MEETING AGENDA

Appearance Commission

Village of Homewood

Topic: Case 24-45: Appearance Review, 2124 W 183rd Street Redevelopment

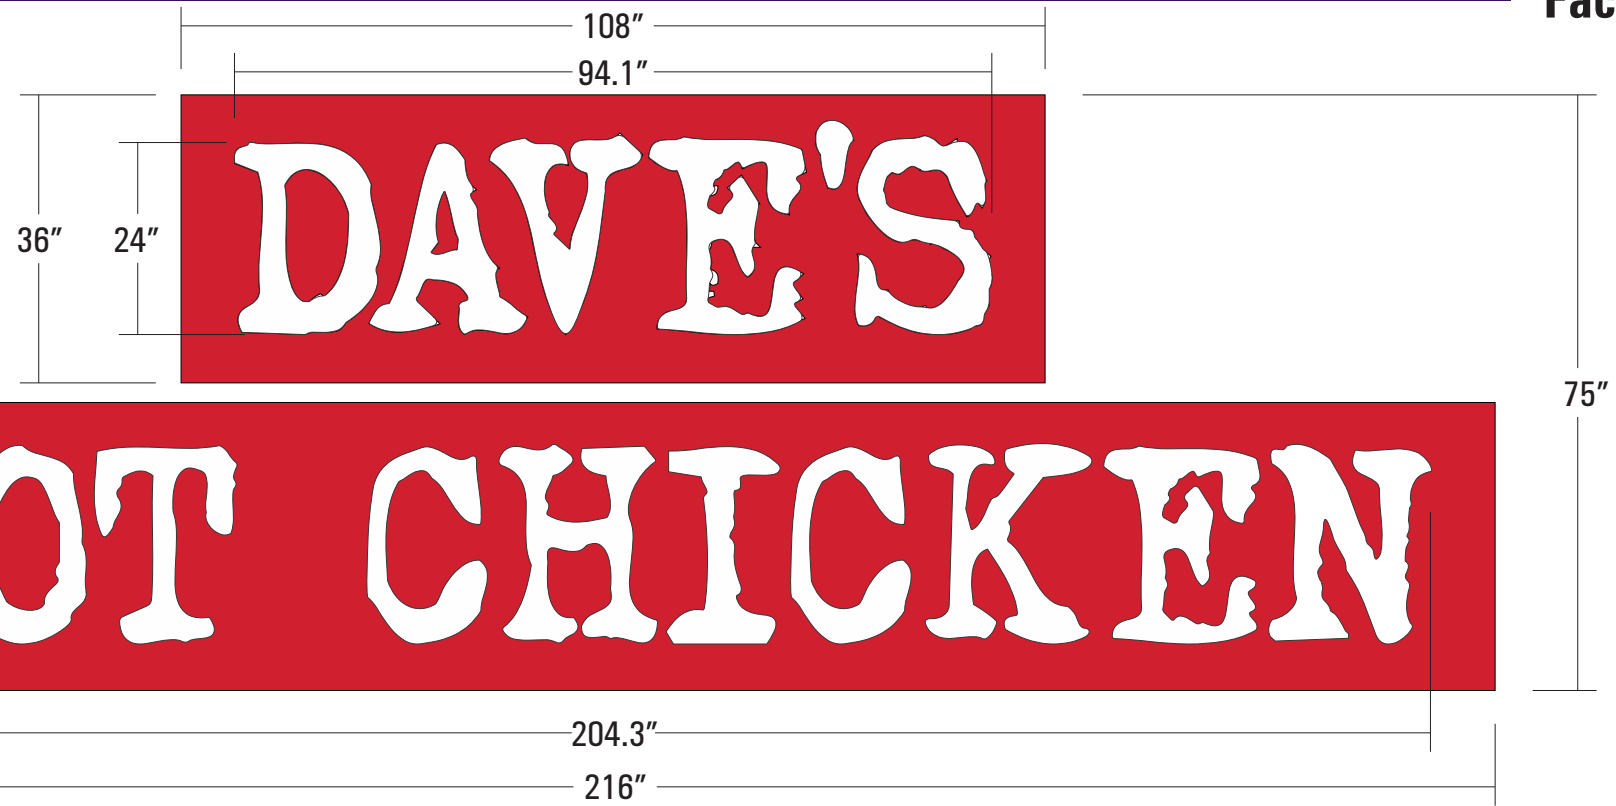
Correct size is 81 square feet with only sign areas measured.

- NS, 11/7/2024
